ADDENDUM NO. 1

DOUGLAS MACARTHUR ELEMENTARY SCHOOL ADDITIONS, RENOVATIONS, AND RELATED WORK Crown Point, IN 46307

ADDENDUM ONE

Addendum One (AD.01) to the drawings and specifications prepared by Gibraltar Design for **MacArthur Elementary School Additions & Renovations** for Crown Point Community School Corporation, Crown Point, Indiana.

A-862

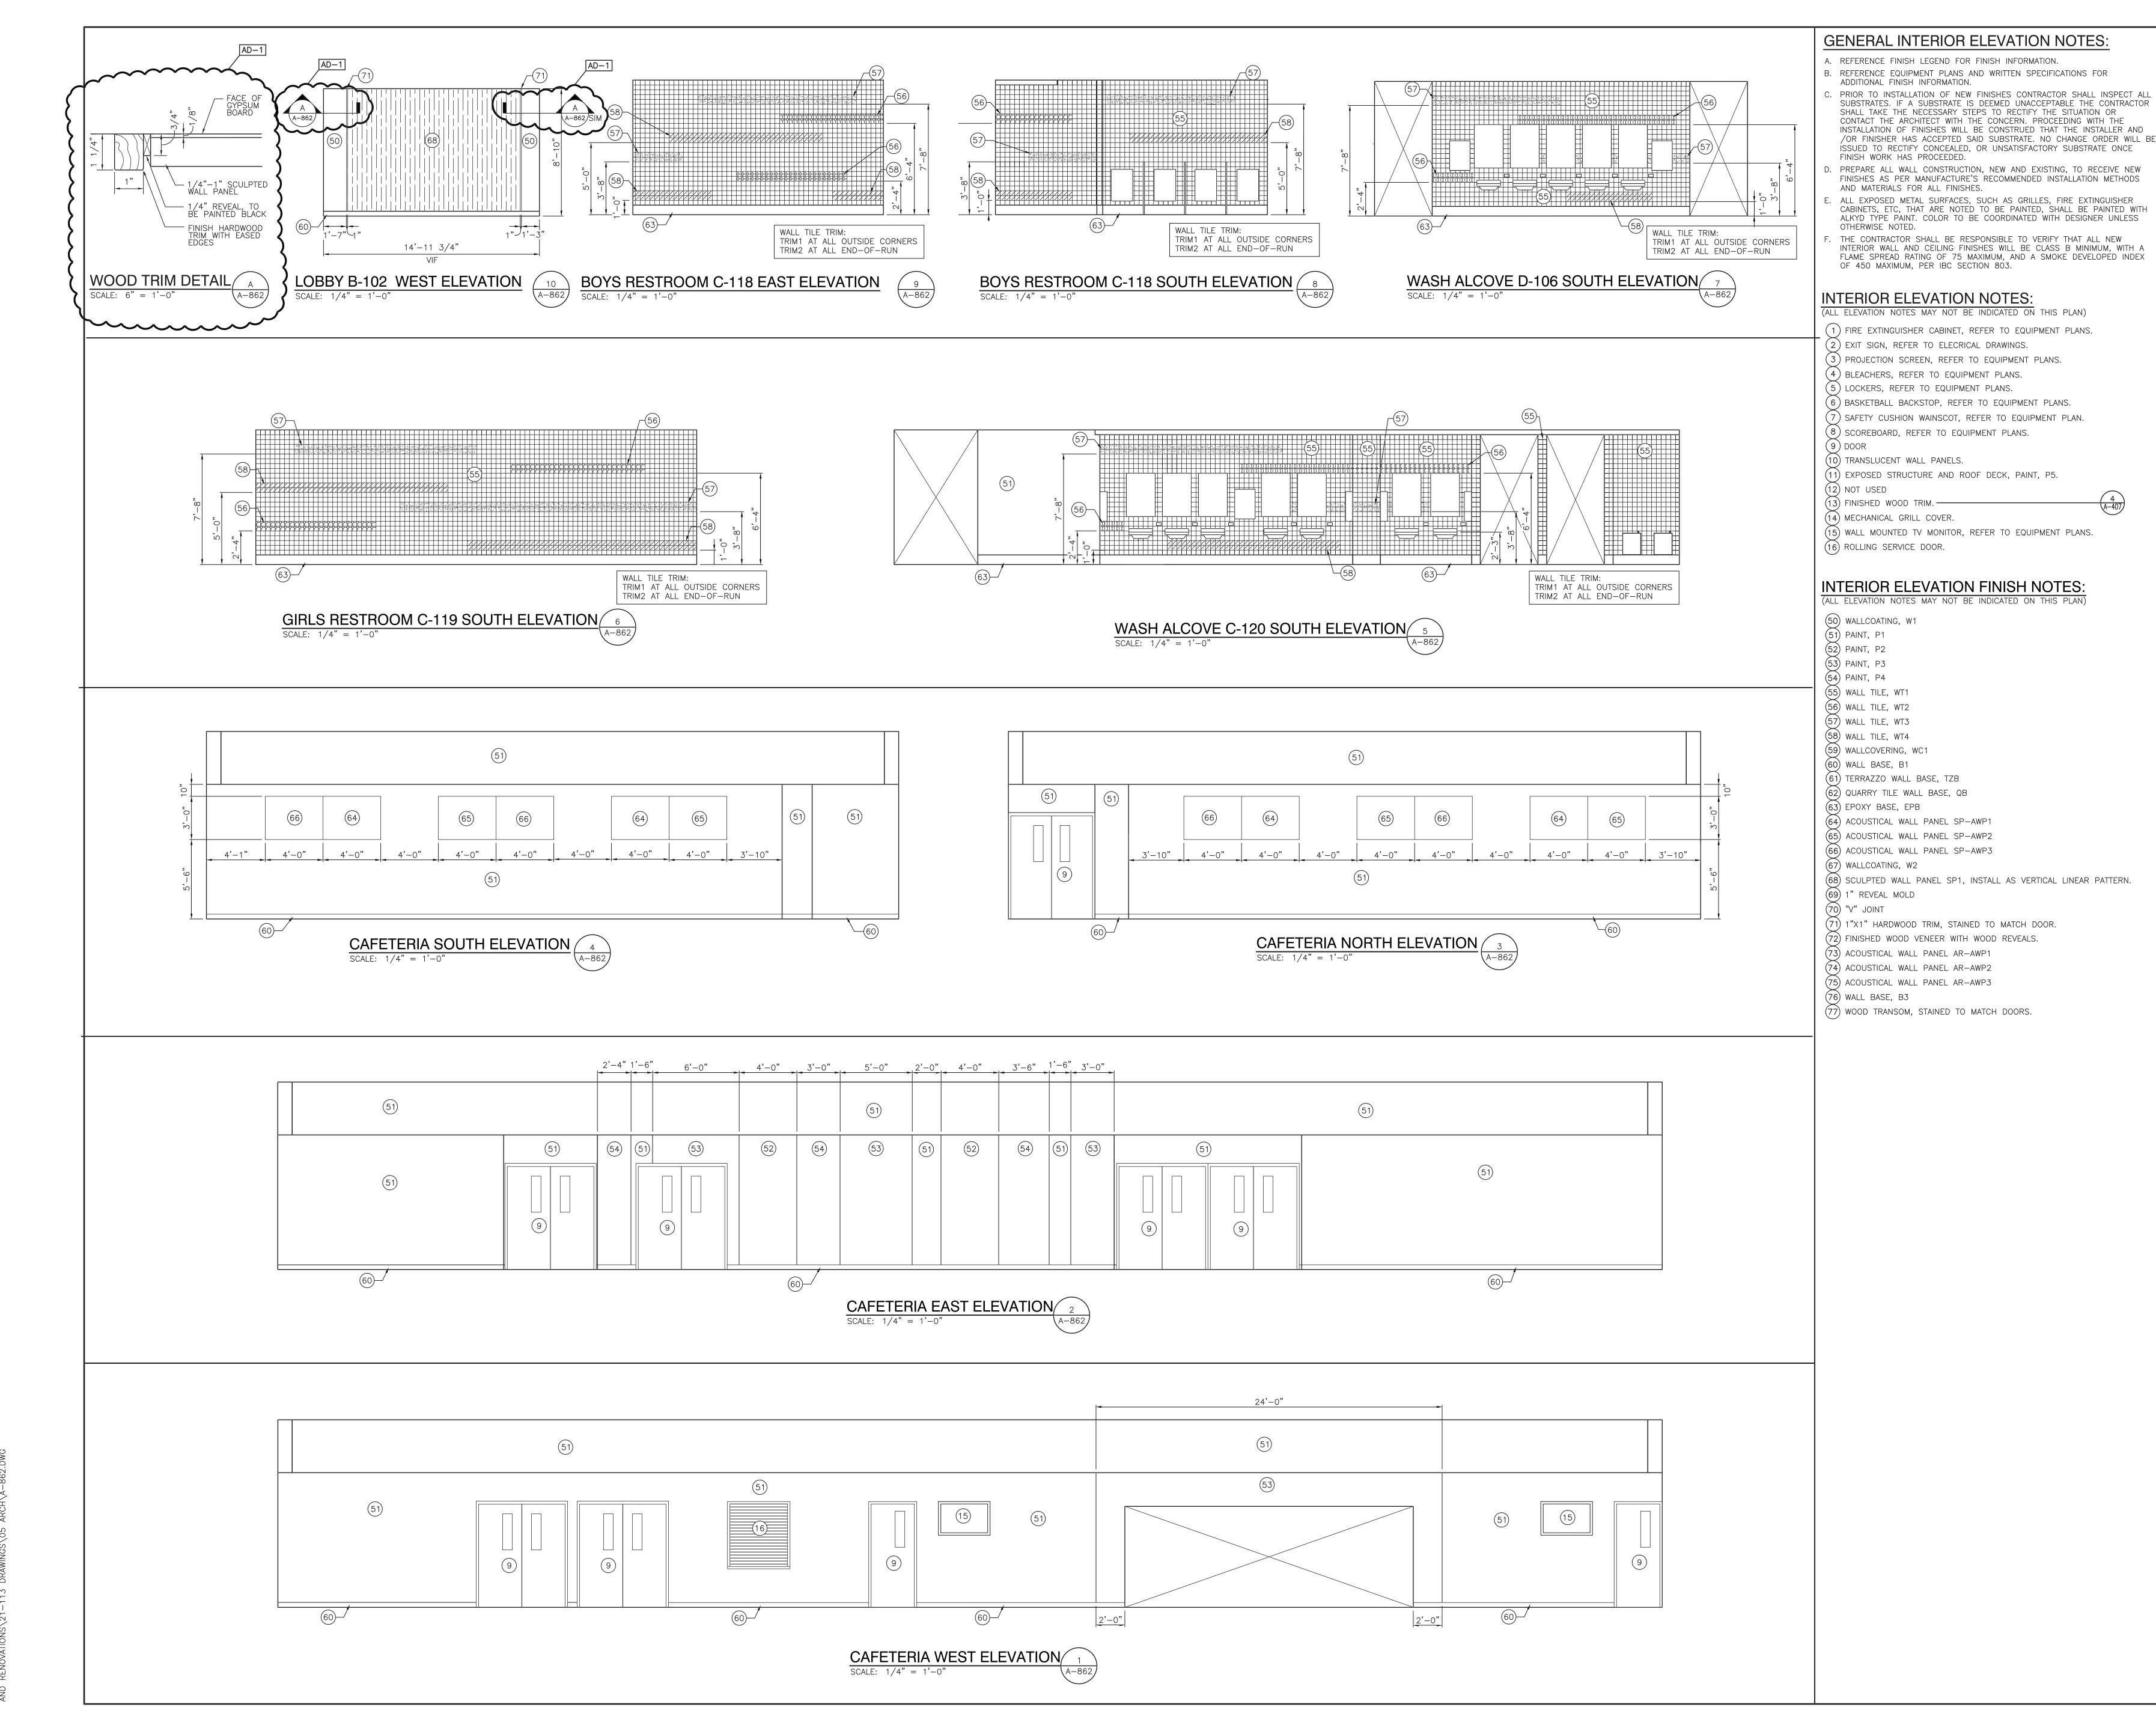
10. Sheet A-862

- A. Refer to revised, full-size drawing, included in this Addendum, for the following revisions:
 - 1. Addition of Wood Trim Detail A/A-862
 - 2. Addition of section cuts to Elevation 10/A-862
